## QUALITY ASSURANCE -- NON-CONFORMANCE REPORT

**Report No:** NCR-000494

**Reference Description:** Missed UT indication on Tower Strut WD1-A305-65M

**Dear:** Mr. Charles Kanapicki  
**Job Name:** SAS Superstructure

<b>Welding</b>	<b>Concrete</b>	<b>Other</b>	
<b>Welding</b>	<b>Curing</b>	<b>Procedural</b>	<b>Bridge No:</b> 34-0006
<b>Joint fit-up</b>	<b>Coating</b>	<b>Other</b>	<b>Component:</b> Tower Strut
<b>Procedural</b>	<b>Procedural</b>	<b>Description:</b> Tower Strut WD1-A305-65M

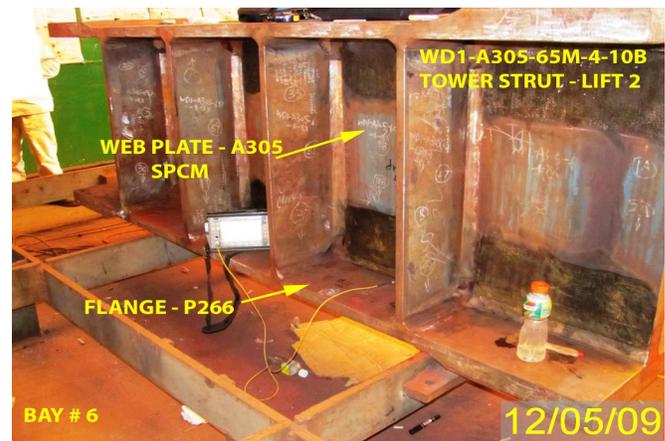
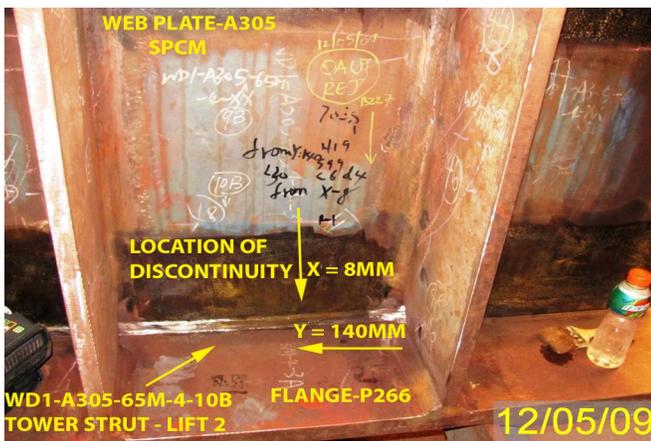
During Ultrasonic Testing (UT) of Strut Web to Flange CJP weld joint WD1-A305-65M-4-10B, QA discovered one (1) Class "A" longitudinal indication, with an indication rating of +6, measuring approximately 30 mm in length. The plate thickness at the location of the indication is 28 mm. This weld was previously tested and accepted by ZPMC QC UT technicians.

AWS D1.5-2002, Section 6, Table 6.3 specifies for material thicknesses of 20mm through 38mm, a decibel (db) indication rating of 8 db or less shall be categorized as Class A (large flaws) and any indication in this category shall be rejected (regardless of length).

Welding  Concrete  Other   
 Welding  Curing  Procedural  **Bridge No:** 34-0006  
 Joint fit-up  Coating  Other  **Component:** Tower Strut  
 Procedural  Procedural  **Description:** Tower Strut WD1-A305-65M

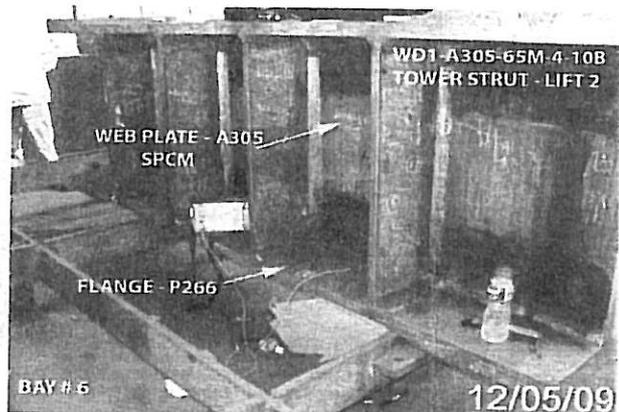
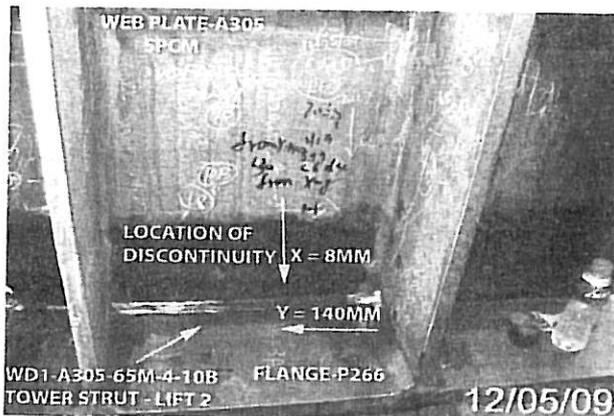
During Ultrasonic Testing (UT) of Strut Web to Flange CJP weld joint WD1-A305-65M-4-10B, QA discovered one (1) Class "A" longitudinal indication, with an indication rating of +6, measuring approximately 30 mm in length. The plate thickness at the location of the indication is 28 mm. This weld was previously tested and accepted by ZPMC QC UT technicians.

AWS D1.5-2002, Section 6, Table 6.3 specifies for material thicknesses of 20mm through 38mm, a decibel (db) indication rating of 8 db or less shall be categorized as Class A (large flaws) and any indication in this category shall be rejected (regardless of length).

WELD NUMBER: WD1-A305-65M-4-10A/B

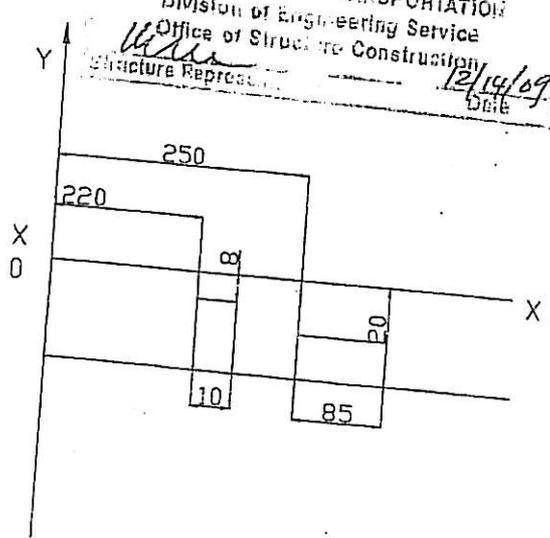
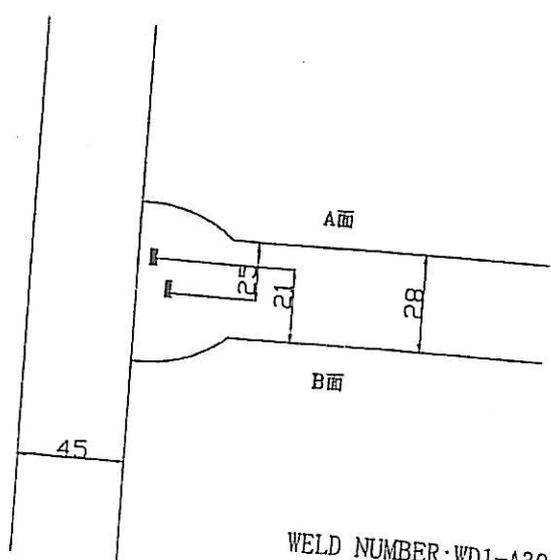
Rejectable indications were found by ultrasonic inspection for a second repair on the A709SL-GR485/345 plate.  
(UT探伤返修第二次, 并且该板为A709M-GR485/345板) WD1-A305-65M-4-10A/B

1. QC shall monitor and direct the welder and the grinder doing the repair operation.
2. Preheat before gouging; the temperature shall be at least 65°C.
3. Gouge the weld to remove identified defects.
4. Joint details shall refer to the approved WPS repair.
5. Grind the gouged areas to a smooth and shiny surface.
6. Verify with VT and MT to ensure no defects remain in the weld joint prior to welding.
7. QC shall monitor all welding passes being deposited.
8. QC shall ensure all slag has been removed prior the deposition of next pass.
9. Preheat and maintain interpass temperature control in accordance with the WPS.
10. Blend the weld repaired areas into the adjacent weld or base metal by grinding.
11. Perform VT, MT and UT NDT inspection to the repaired areas.
